工程指示 / 要求簡箋(E.I.)

工程指示編號：EI / 5754 / 23

工程名稱：將軍澳日出康城 11

工程項目：偏林箱 生產 樣板層 4 件(鉻化)(第二次) 雀網版本

類別		物料號	
制圖	胡冬雲	2023.1.10	圖號 858-PL-BOX01
修改	A	-	數量 146+4(後備)=150
日期	2023.2.17	-	位置
復核	-	-	
批准

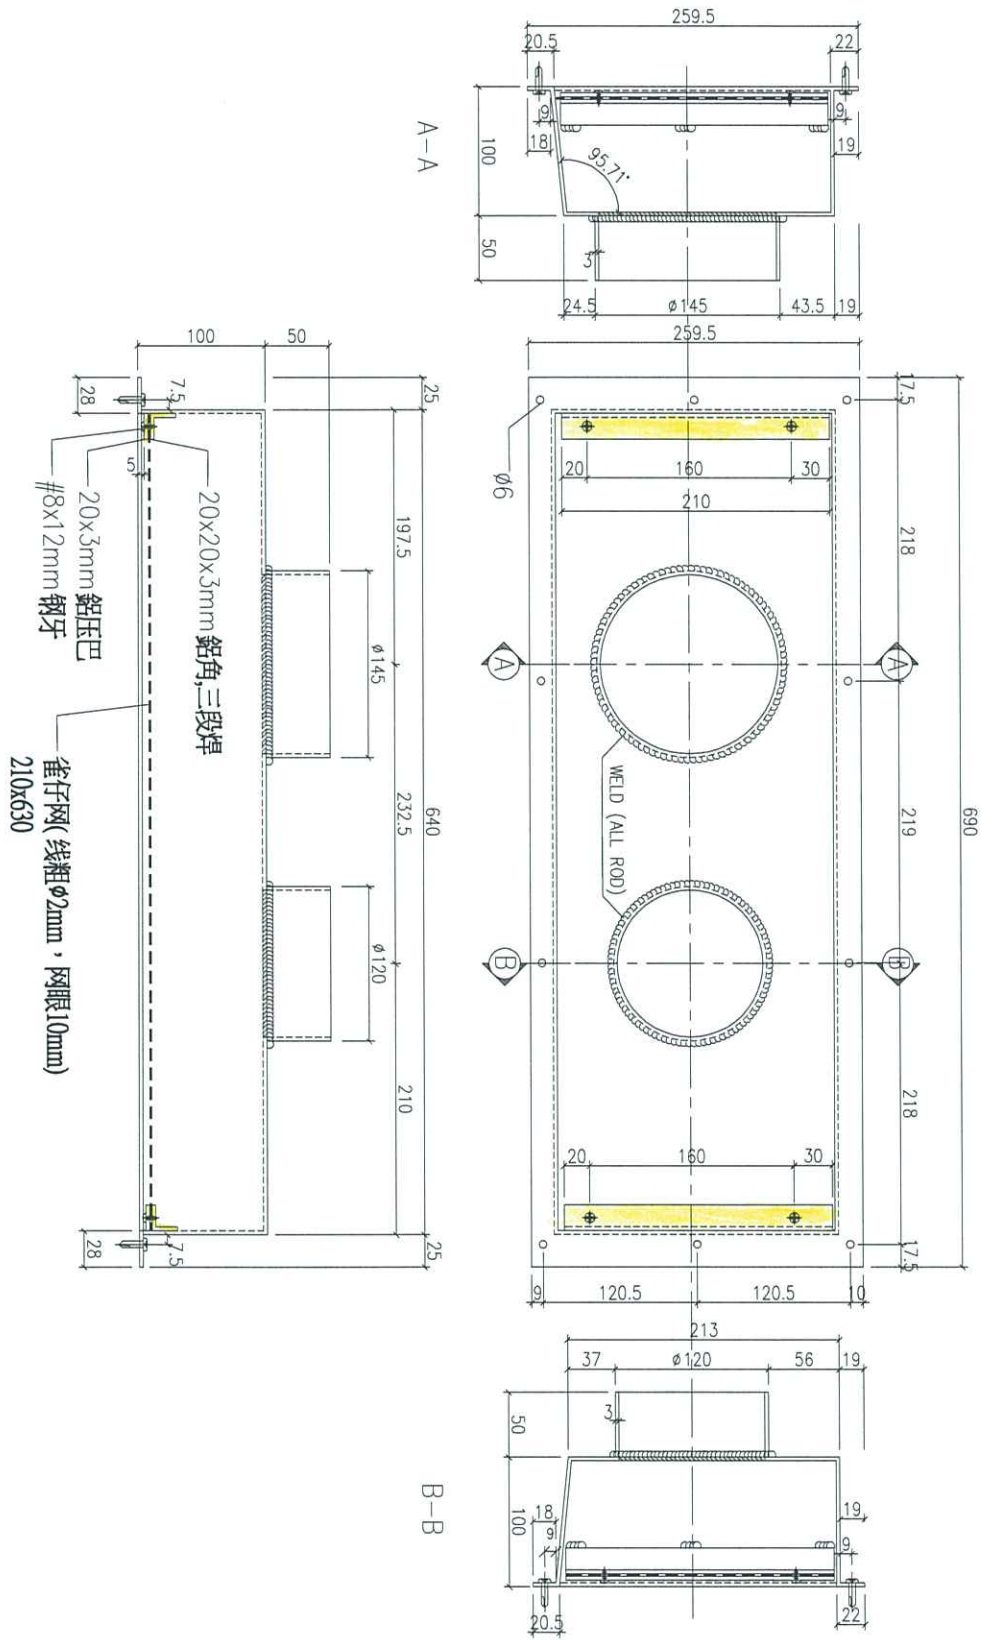
請生產偏林箱共 4 件 (雀網版本)。

所有偏林箱，需要鉻化。3mm 厚

加雀網(線粗  $\phi$  2mm，網眼 10mm) 316 料
